# CITY OF ALBUQUERQUE

**Re: Village At Avalon- Phase 1**  
**601 90<sup>th</sup> St. NW**  
**30-Day Temporary Certificate of Occupancy- Transportation Development**  
**Transportation Development Final Inspection**  
Architect's Stamp dated 12-9-15 (K09D040)  
Certification dated 9-22-17

RE: Village at Avalon  
601 90<sup>th</sup> Street NW  
Zone: SU-2 for R2 Uses  
Submittal: TCL for Final C.O. of Phase 1

SDP-1.1

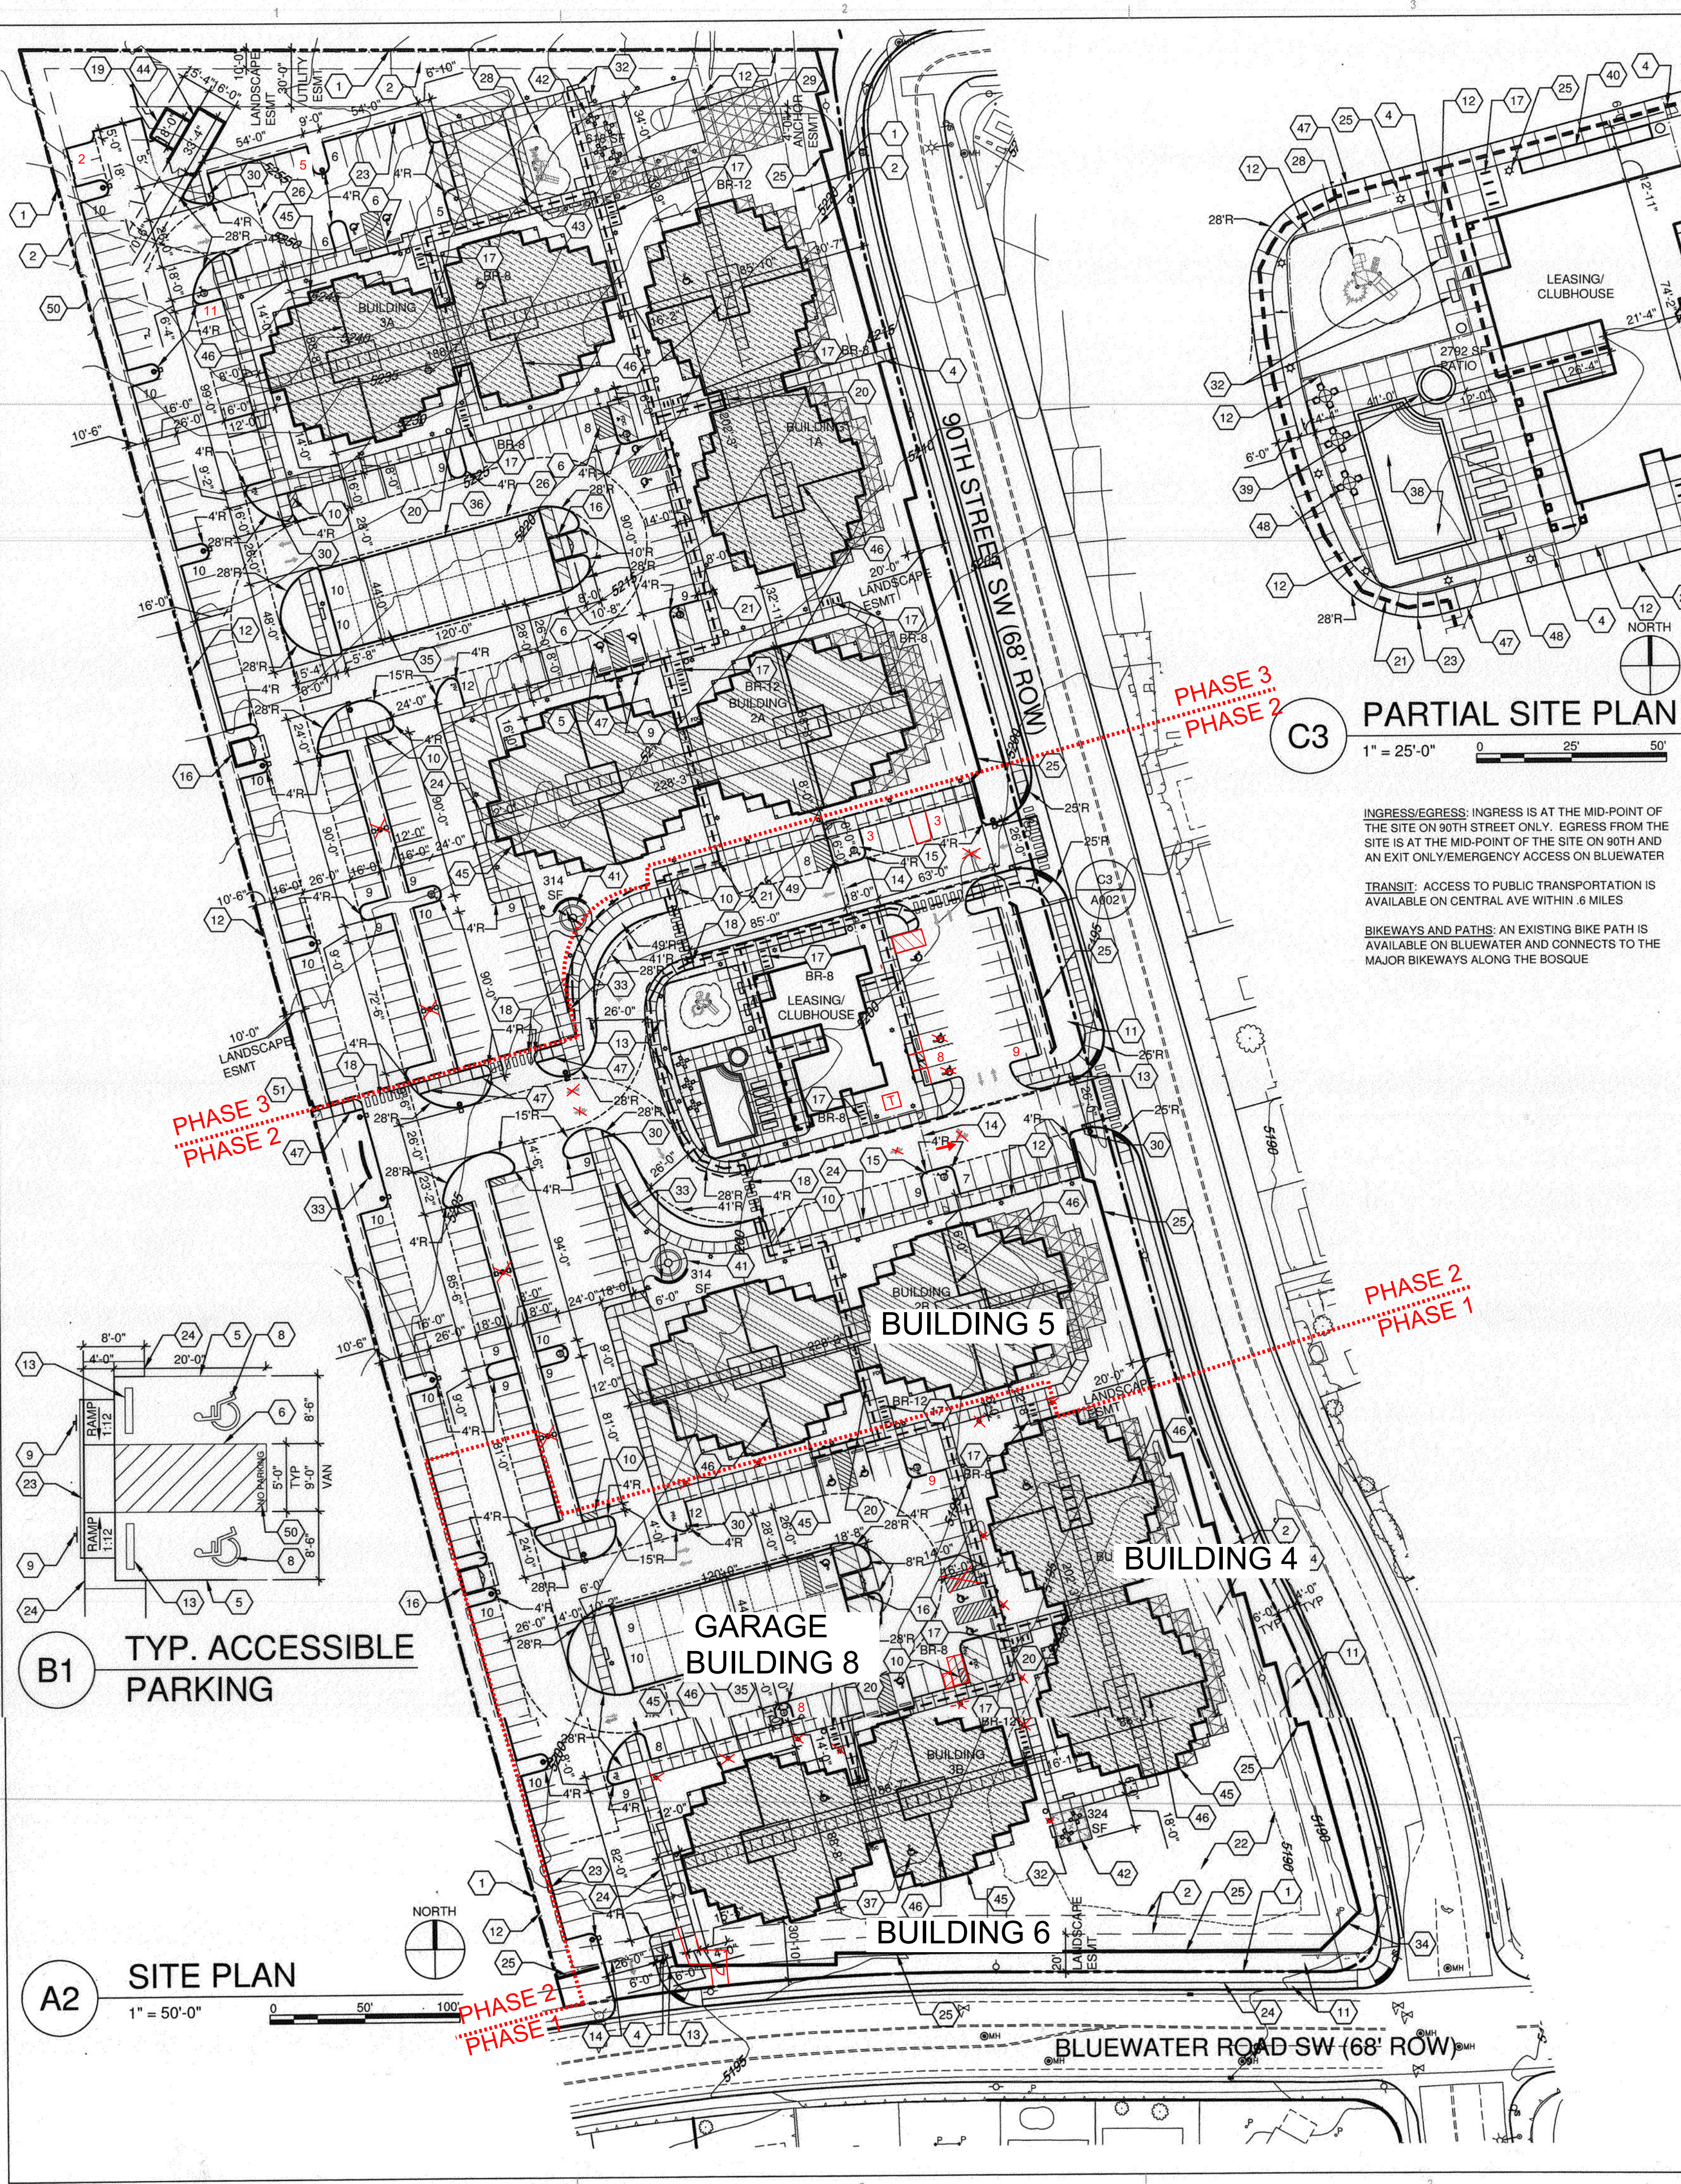
1. The proposed Motorcycle parking space on the northwest side of phase 1 improvement has not been constructed per plan.
2. The Certification of Occupancy must be, stamped, signed, dated by an engineer or architect licensed in the State of New Mexico.

- Traffic gate controllers are not installed yet, installation to be completed 9/25/2017
- Minor modification of parking lot striping are marked on the attached SDP As-built
- Concrete sidewalk and gate were relocated, this change is marked on the attached SDP As-built
- Site lighting is primarily achieved through wall packs on the buildings and pedestrian pole lights shown on the SDP were eliminated.
